8 July 2022

RE: INTERIM AUDIT ADVICE LETTER NO. 4 - SSD 8925 MOD 7, THE NEW SYDNEY FISH MARKET

This fourth Interim Audit Advice Letter (**IAA #4**) has been prepared to address new requirements for Condition B93 which requires audit review of the letter 'Re: *Sediment Capping – Environmental Assessment, New Sydney Fish Market*', 15 February 2022, Senversa Pty Ltd (Senvessa) (**the Capping Methodology Letter**).

Attachment 3 - Cross Section of Cap and Relative Water Levels

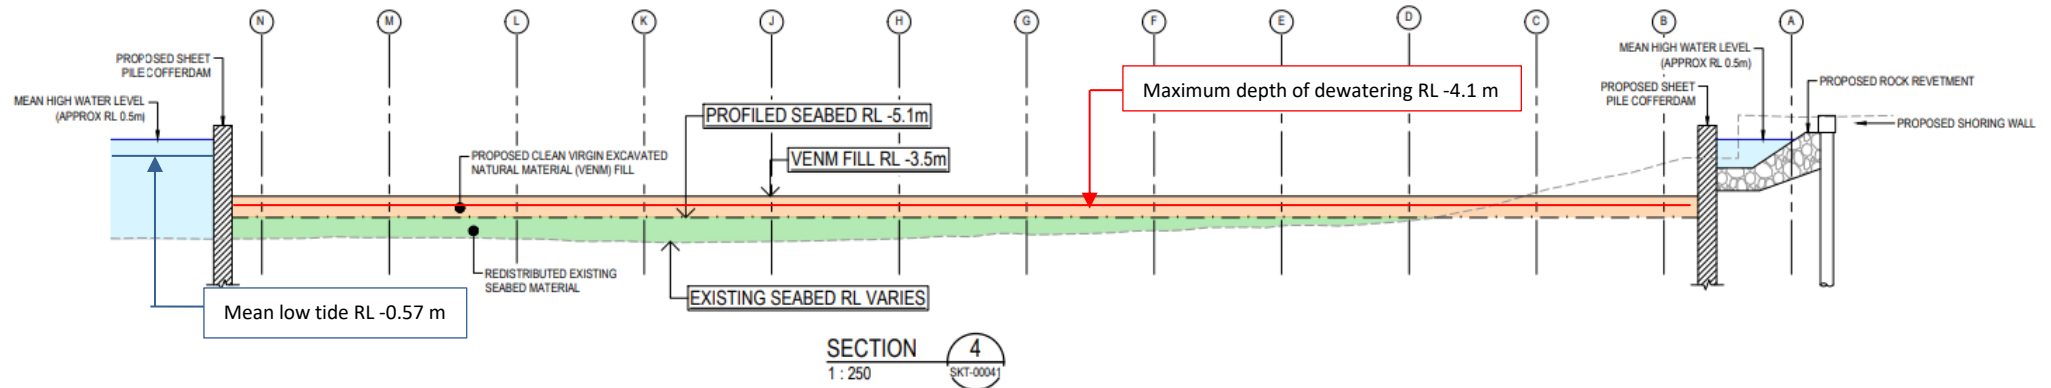
The Capping Methodology Letter indicates the platform is to be made up of two 600 mm bands of clean virgin excavated natural material (VENM) sand followed by a 400 mm layer of crushed stone (VENM). The sand is to be installed prior to dewatering (marine based installation) using a hopper barge with sand to be pumped directly to the workface via a hydraulically driven submersible pump.

At completion, the level of the sand layers will be -3.9 AHD, which is 200 mm above the dewater level. Following dewatering, the remaining capping layer of crushed stone will be installed via land-based machinery building the sediment level up to -3.5 AHD, which is approximately 2.93 m below mean low water tide (-0.57 AHD).

Based on this methodology, the potential acid sulfate soil (PASS) sediments will remain submerged beneath 1 m of water and sand after dewatering (with 200 mm of sand and 400 mm of crushed stone above the dewater level during works). In total the cap will be 1.6 m thick.

A cross section of the proposed cap and relative water level is shown on **Attachment 3**.

Given that the sediments are to remain water-logged, the proposed works are not expected to result in significant oxidation. Therefore, subject to appropriate validation of the imported VENM in accordance with the Revised RAP, I am of the opinion that the proposed capping is acceptable.
